30 January 1976

SERVICE BULLETIN - 105

RALLY VENT MODIFICATION

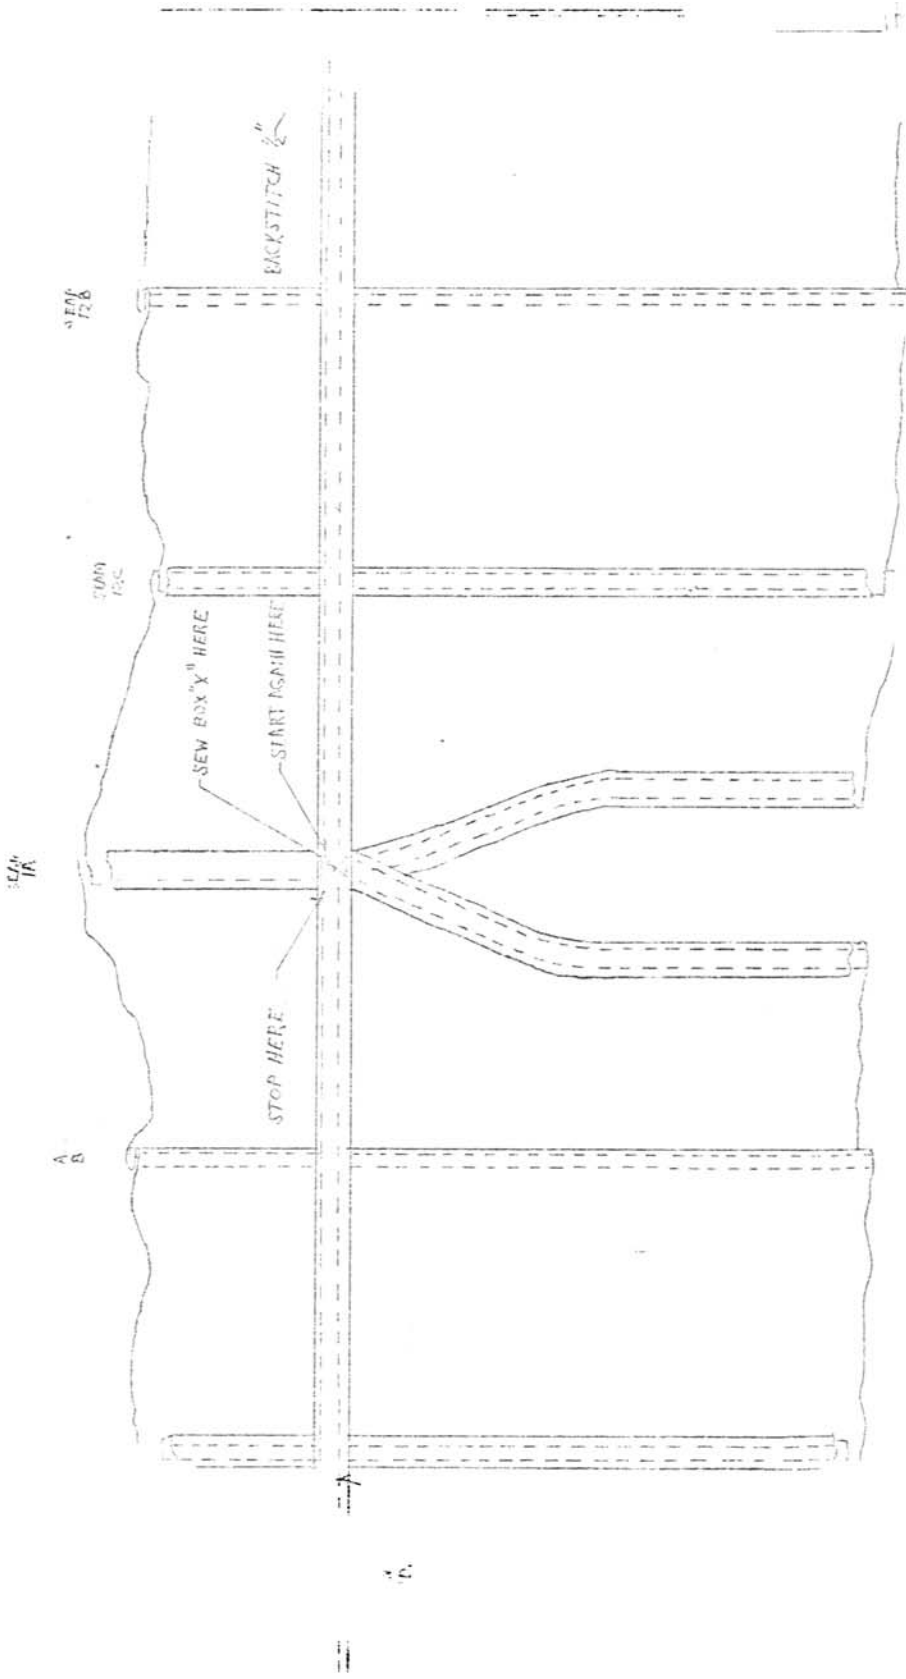
A partial circumferential load tape should be installed, according to instructions contained herein, on the outside of the envelope to reinforce the vent area. The tape should run horizontal at the top of the maneuvering vent. It should be installed on your Rally hot air balloon immediately if your balloon has more than 50 hours of flight time, or within one month or 50 hours total flight time, whichever comes first.

Sew the one inch wide nylon tape, which is enclosed, circumferentially starting at seam 2A and sew continuously across seams 1C, 1B, and up to vent opening, Seam 1A. (Be careful to hold vent flaps out of the way.) The circumferential tape should cross the vent opening at the extreme top of the opening as shown in Drawing B-14527. At the very top of the vent opening lay the vent edge tapes one on top of the other as would be the case with the vent closed. Move the inner vent flaps out of the way and starting on the right hand side of seam 1A sew to seam 12A crossing seams 12C and 12B. Terminate and back stitch 1/2 inch on seam 12A. Cut off excess tape and loose threads.

The final step in securing the circumferential tape consists of sewing a box "X" stitch pattern, as shown, over the area where the circumferential tapes cross the vent edge tapes. Again, use caution NOT to include the internal vent flaps in the stitching.

The tape should be sewn using two rows of lock stitches with 1/2 to 3/8 inch between rows. Polyester thread having a minimum breaking strength of 8.0 lbs should be used. (Thread type MIL-T-285, Type I or II, Class 1 or 2, size "E" or "F" is approved.)
